ALLEGHENY COUNTY SANITARY AUTHORITY

CONTRACT NO. 1735 G, E, H, P

ALCOSAN PARKING GARAGE

ADDENDUM NO. 1

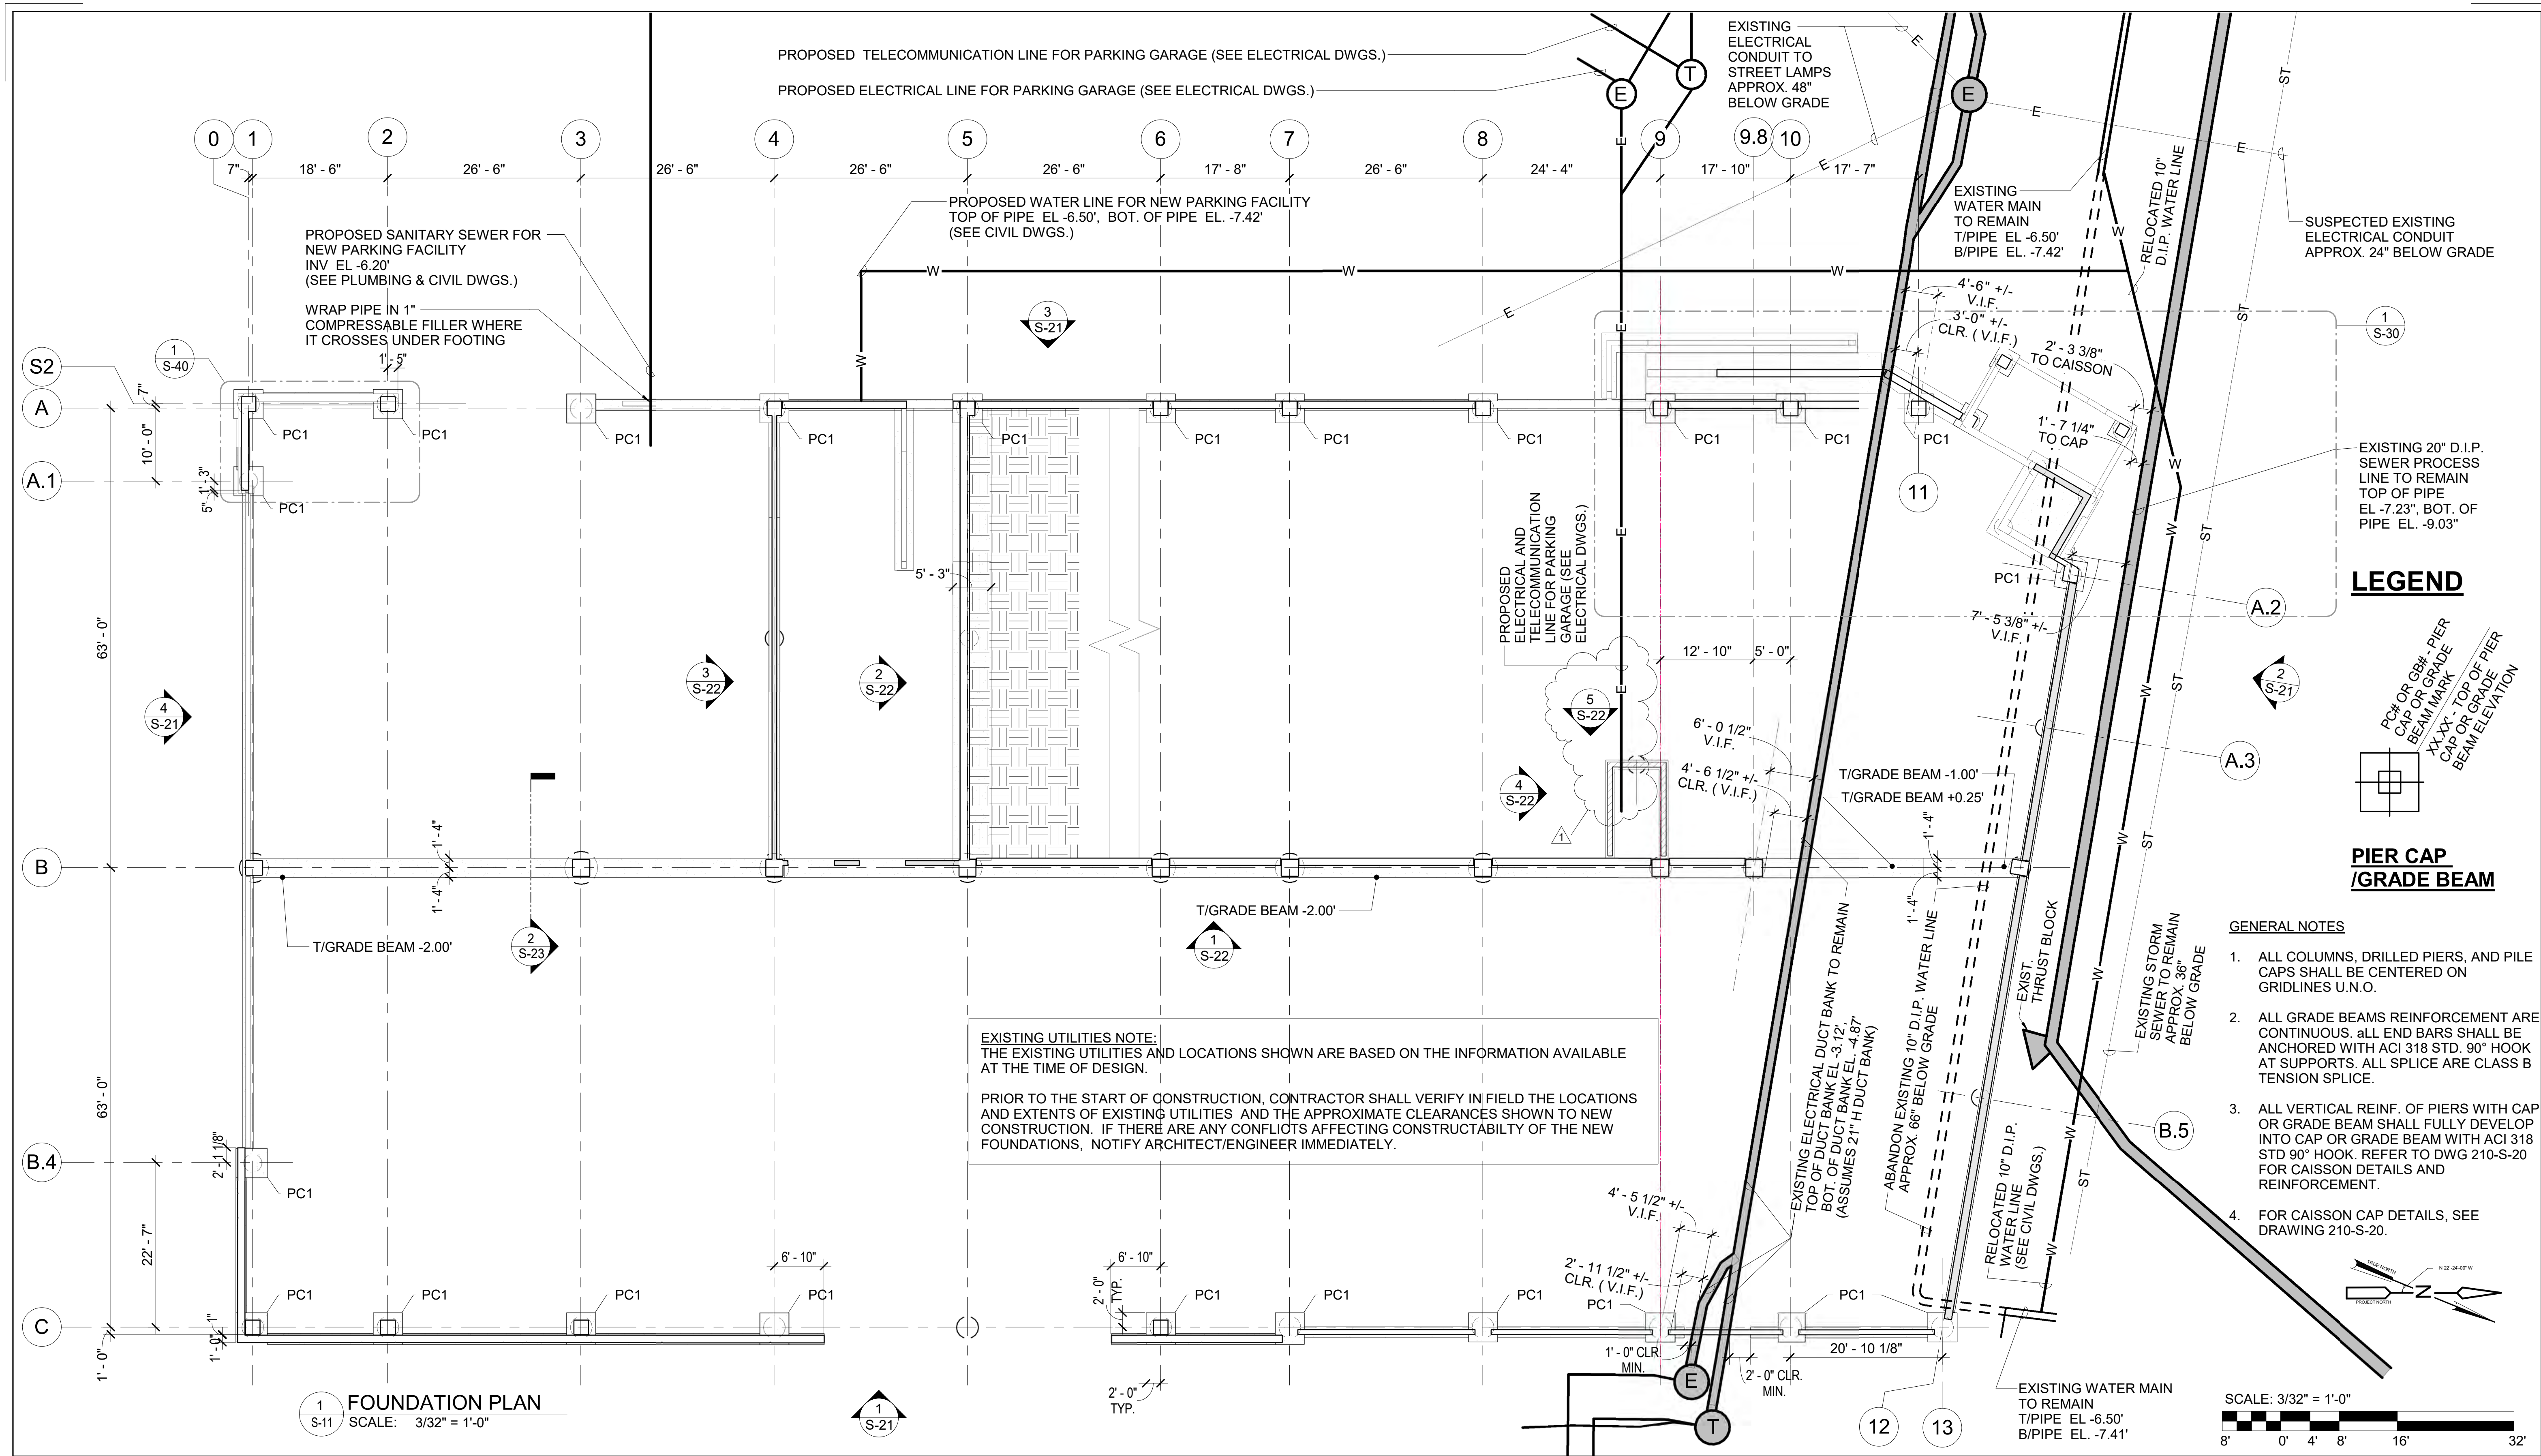
8. Drawing 210-S-11 Foundation Plan:
 - a. REPLACE with the attached drawing 210-S-11.
 - b. Caisson 2.5 has been added between gridlines 8 and 9.

- c. Proposed electrical and telecom line for parking garage has been shifted slightly south to avoid added caisson.
- 9. Drawing 210-S-12 Ground Level Plan:

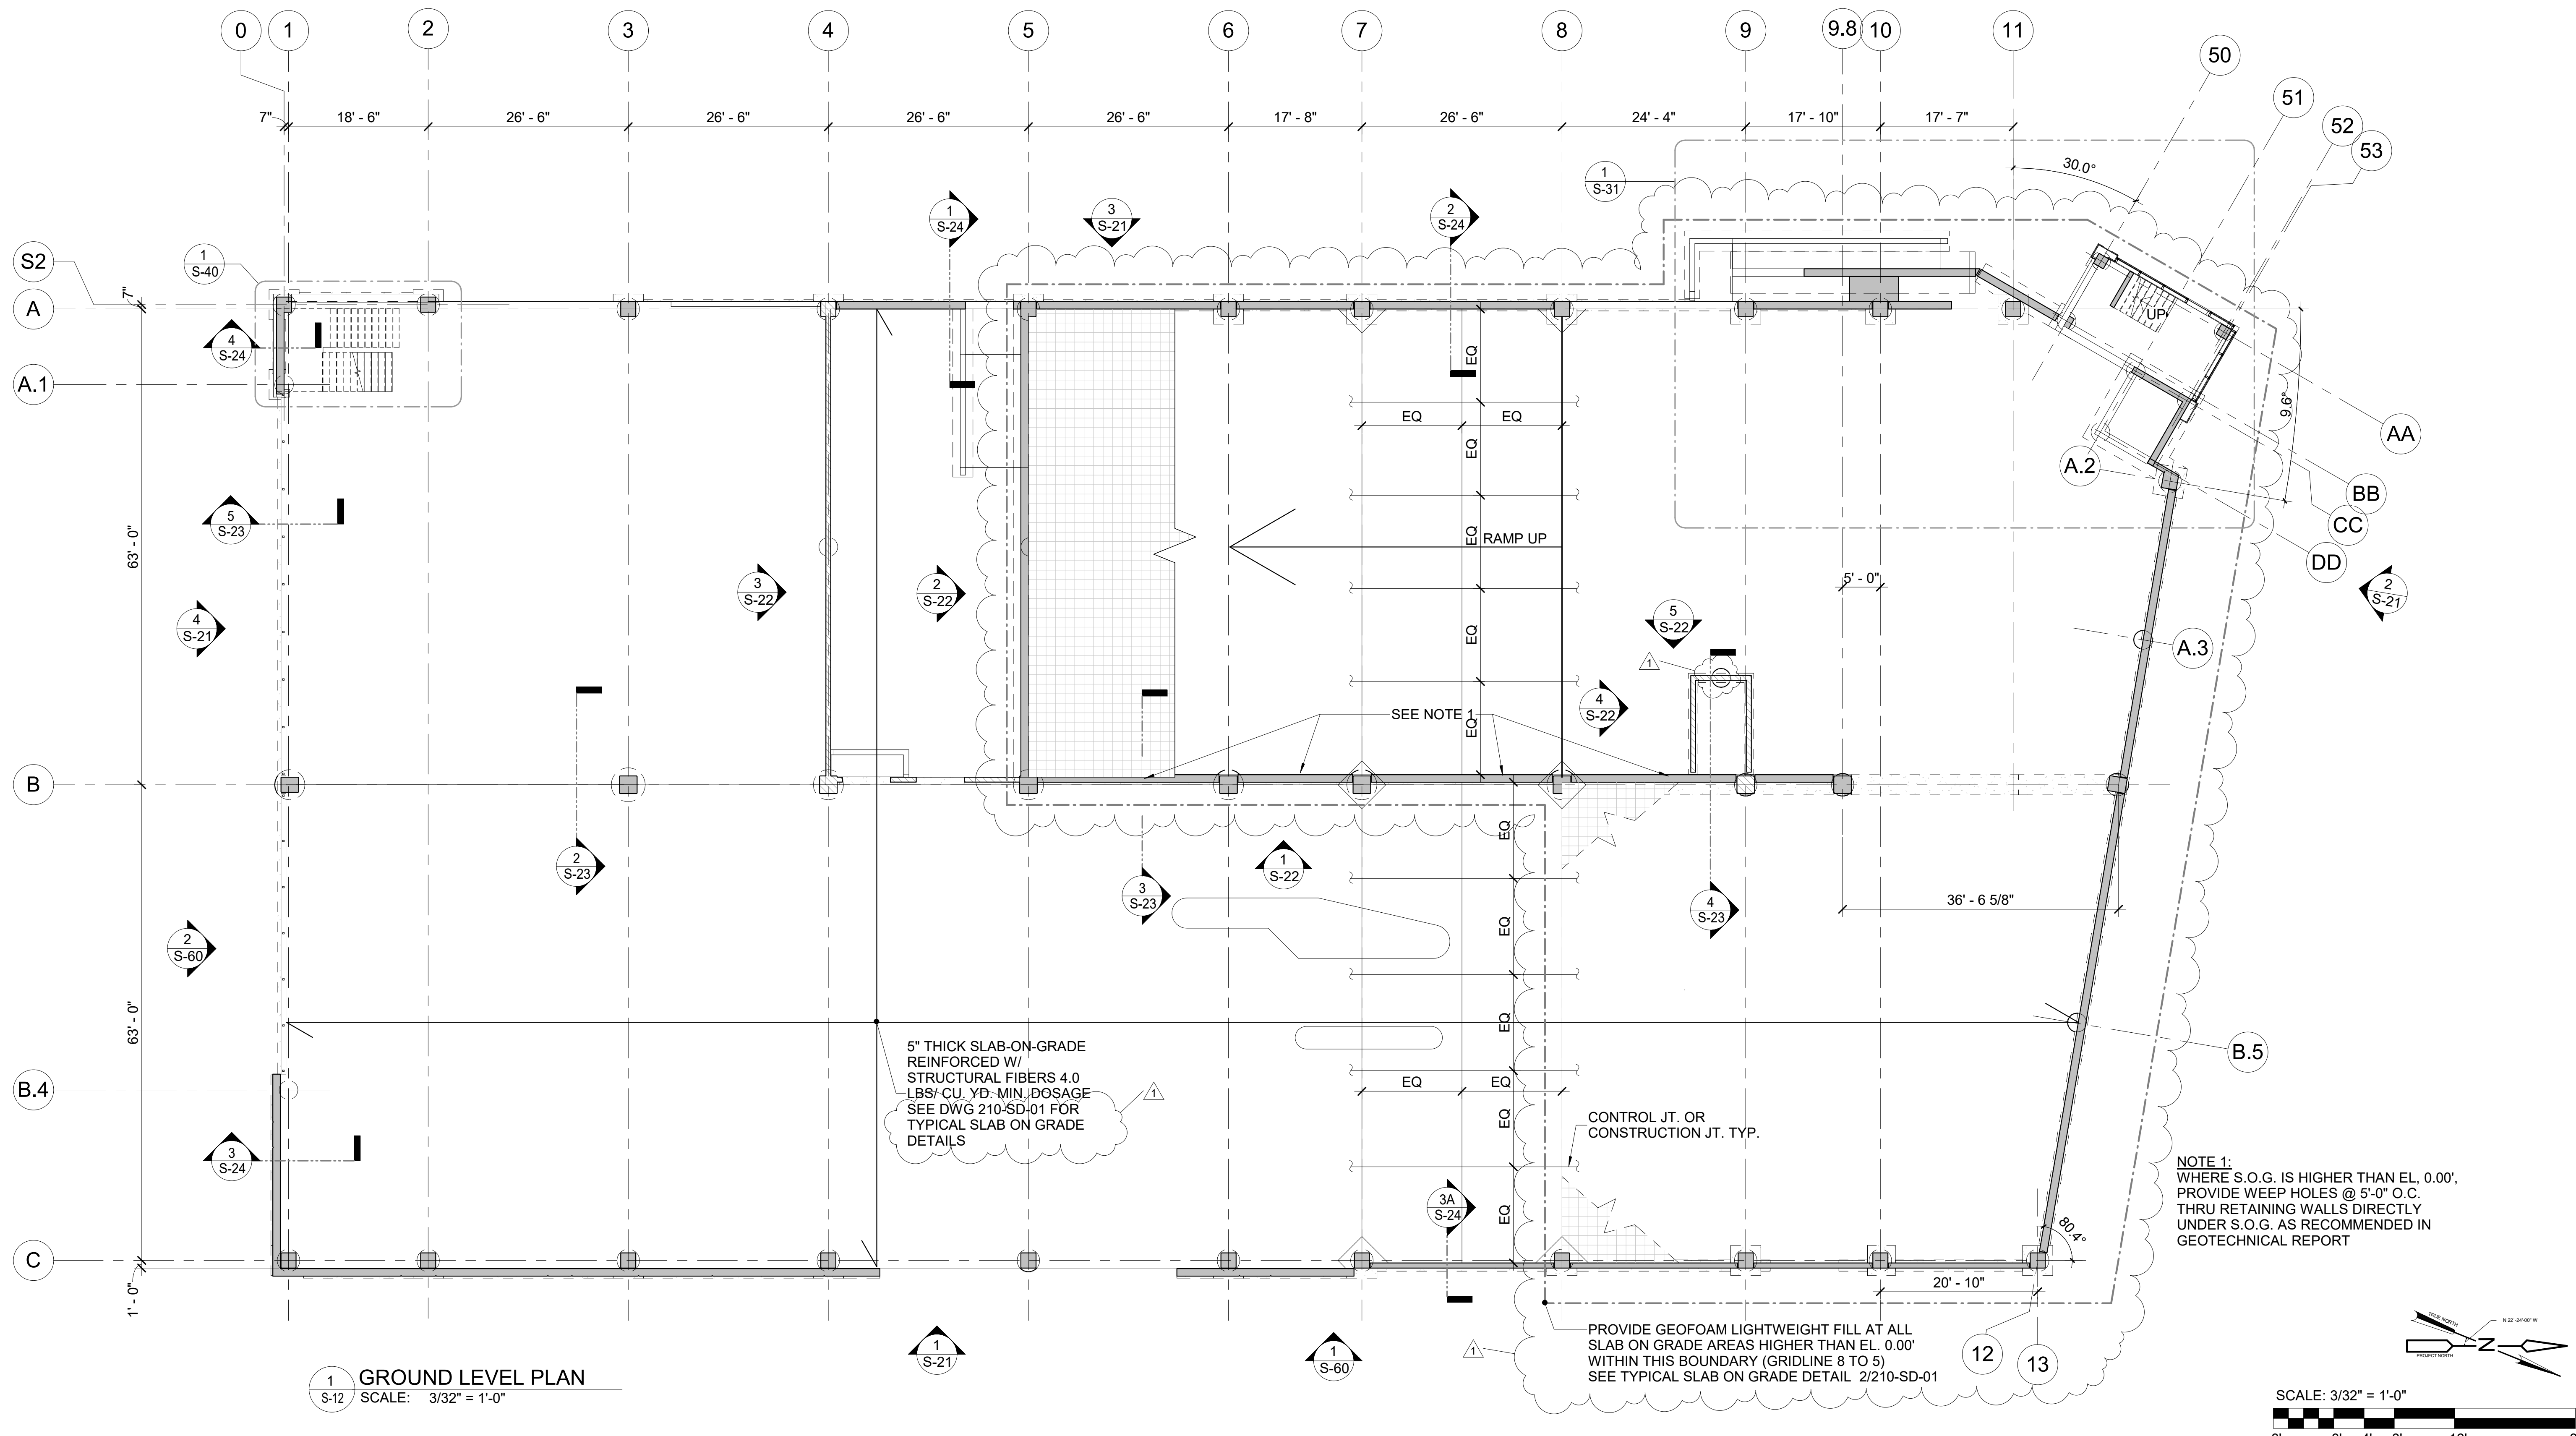
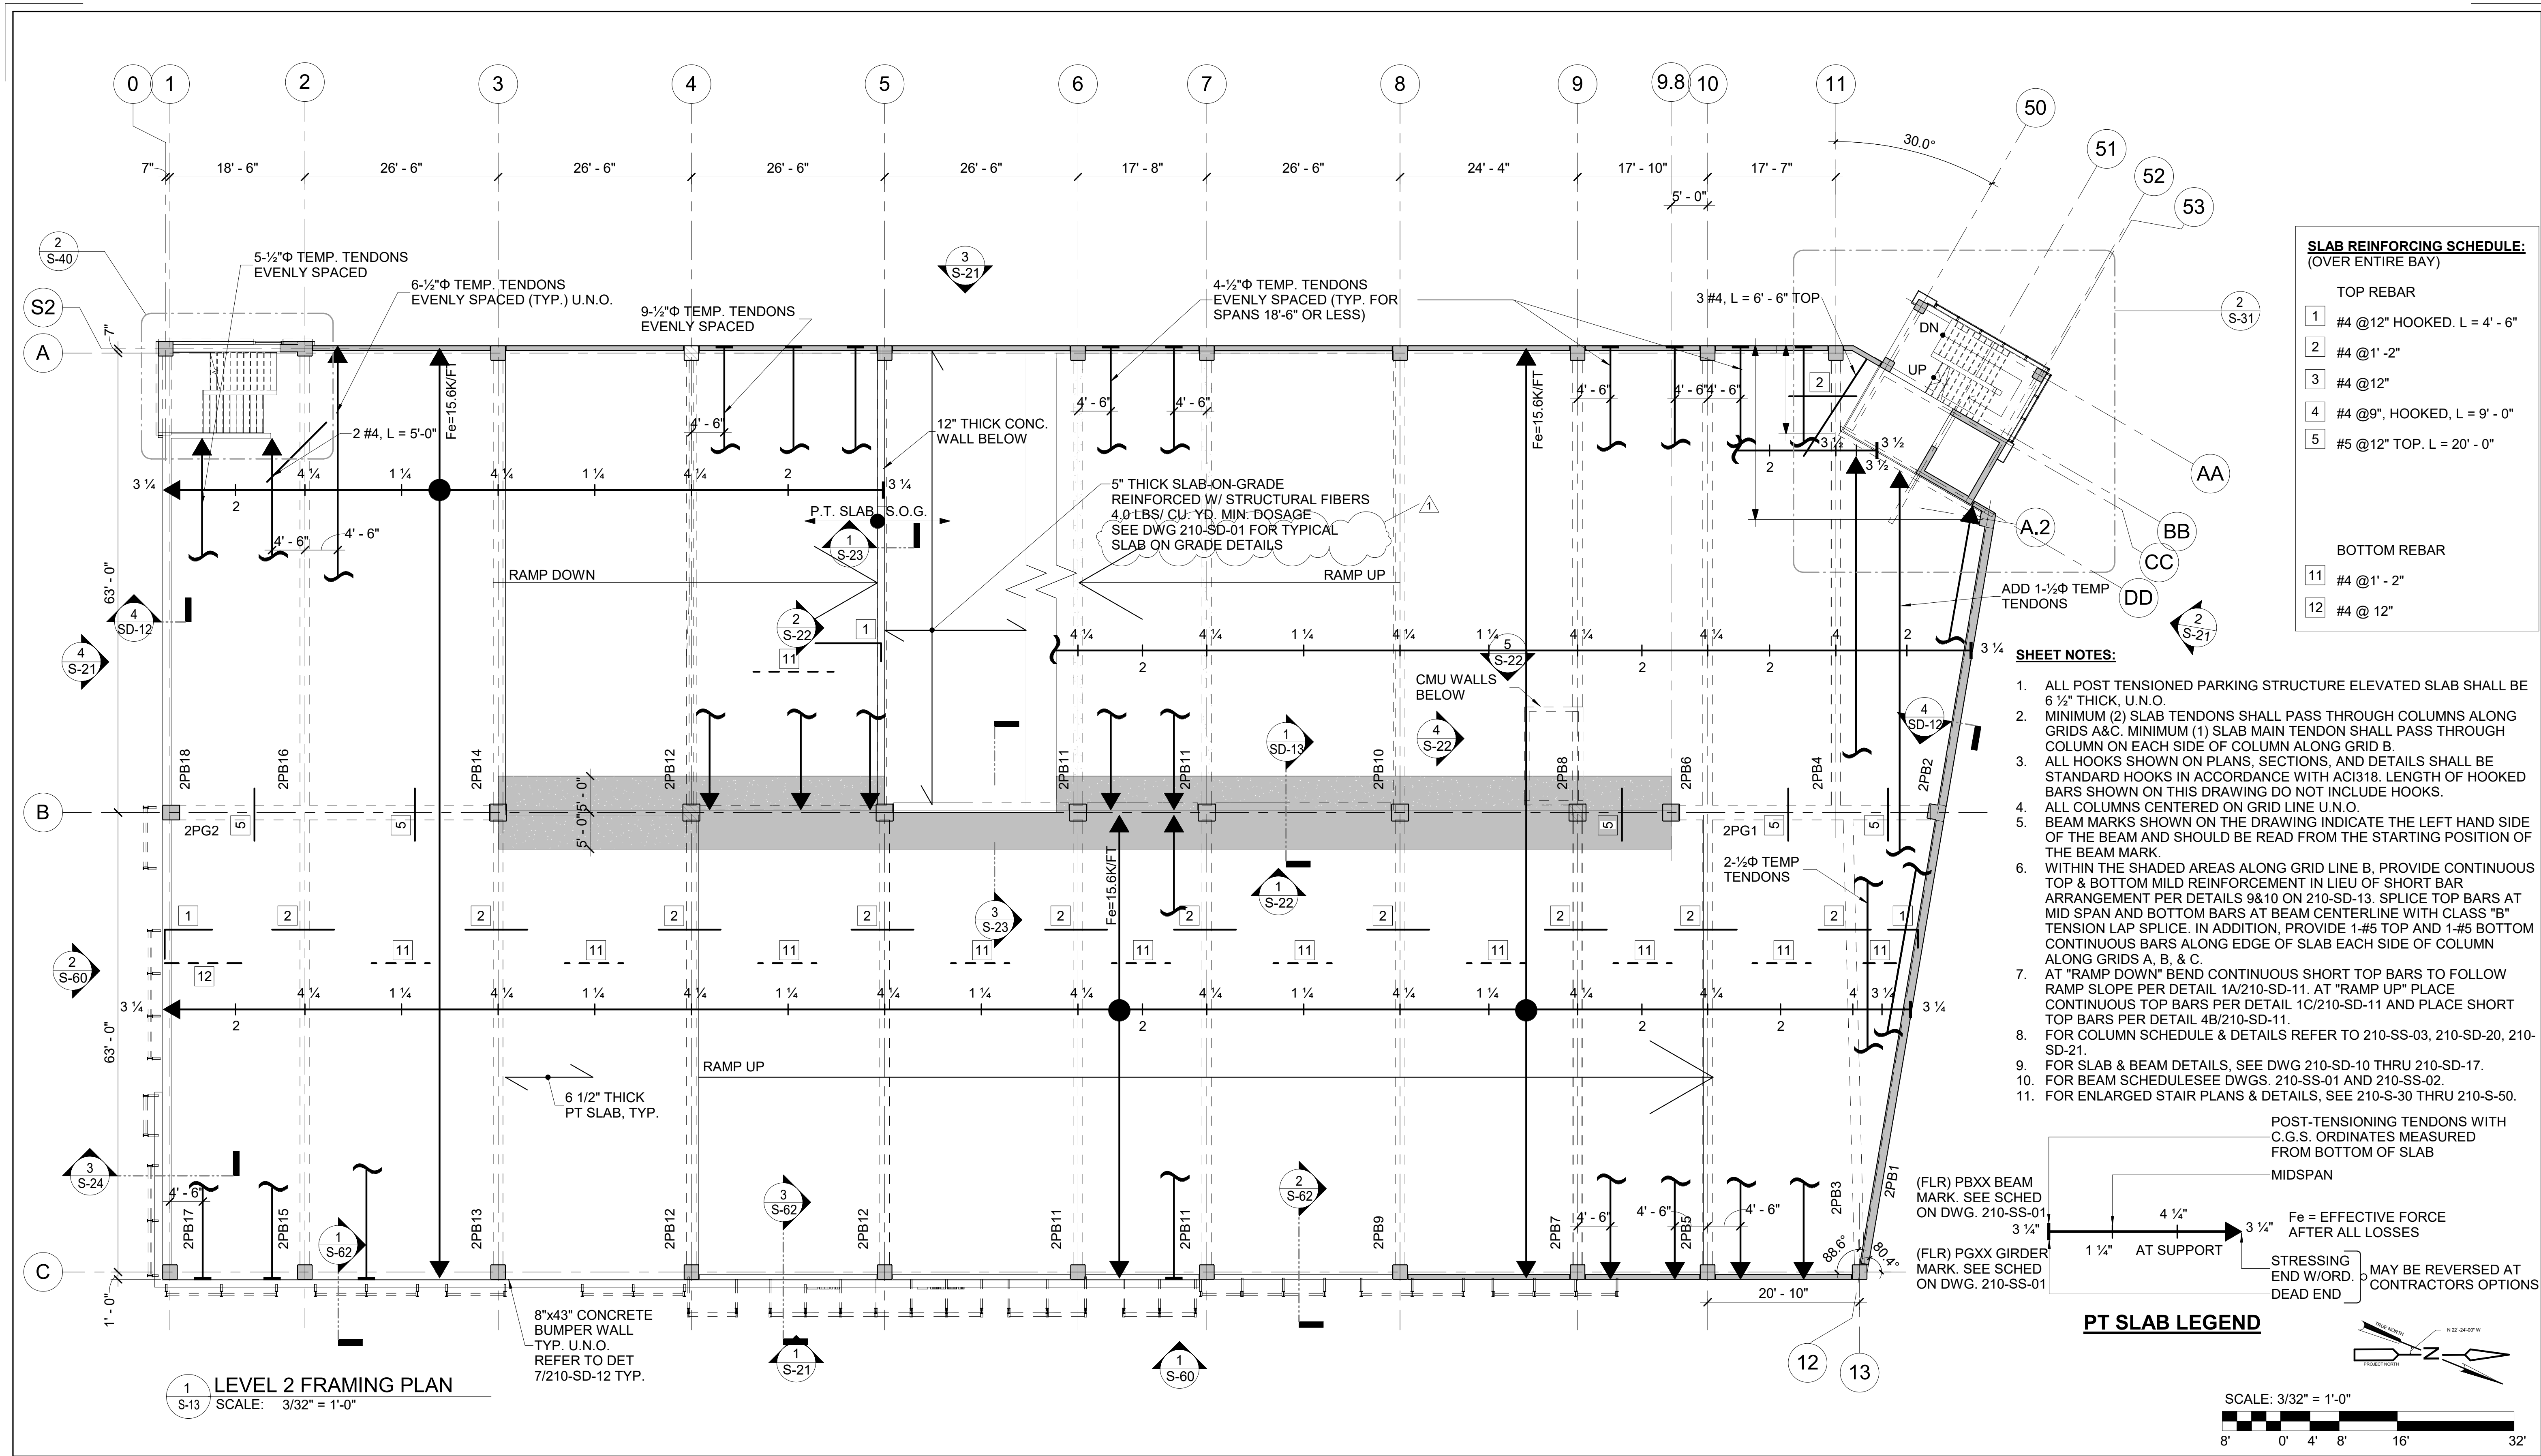
- a. REPLACE with the attached drawing 210-S-12.
 - b. Caisson C2.5 has been added between gridlines 8 and 9.
 - c. Extent of geofoam lightweight fill has been clarified.

- d. Slab on grade note has been modified.
- 10. Drawing 210-S-13 Level 2 Framing Plan:
 - a. At slab on grade note, ADD: "See drawing 210-SD-01 for typical slab on grade details."
